# Sub Regional RTEP Committee PJM South

May 21, 2020

Existing (b3098) Scope and Cost Modification

Revised: Balcony Falls Substation Rebuild (New Scope)

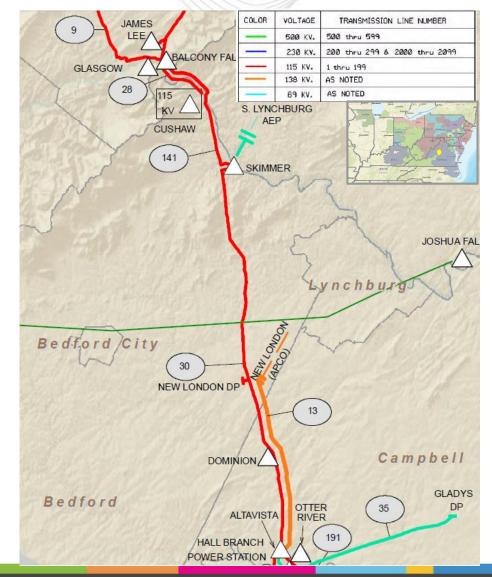
115kV Line #141 extends 9.8 miles between Balcony Falls and Skimmer. For 3.8 miles this line was constructed on a combination of double circuit Blaw Knox structures and shares with 115kV Line #28 and single circuit wood H-frame structures. Rest of line #141 is a combination of wood H-frame and Blaw Knox towers to Skimmer.

The Blaw Knox structures between Balcony Falls and Skimmer were constructed in the 1920's, are showing deterioration, and are reaching the end of their useful service life. Wood H-frame structures for both lines are experiencing ground line deterioration, cracking, splitting, or woodpecker holes and have been identified for replacement.

Approximately 9.2 miles of Line #141 and 3.9 miles of Line #28 have 4/0 ACSR conductor that was installed in the 1920's. Industry guidelines indicate equipment life for wood structures is 35-55 years, conductor and connectors are 40-60 years, and porcelain insulators are 50 years.

Replace all Line #141 and Line #28 structures and both lines will be rebuilt to current standards with a minimum rating of 261MVA. (Est. cost \$20M)

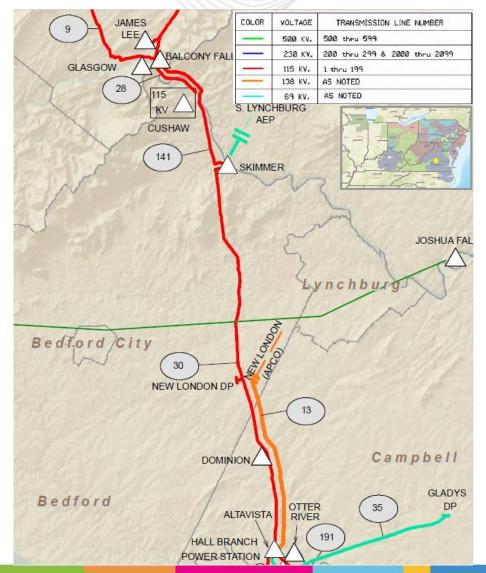
a. The Balcony Falls was part of our acquisitions from APL and it appears the lattice structure that all 4 lines and the cross bus terminate on was built in 1926.

b. Visually it appears that the galvanizing is moderately to severely worn along large portions of the structure. Our structural group does not want to make any changes that would require additional stress be placed on this structure

- (Same as original solution) Rebuild the main line #141 and line #28 to current standards. (Est. cost \$20M)
- (New) Rebuild Balcony Falls Substation (Est. cost \$9M)
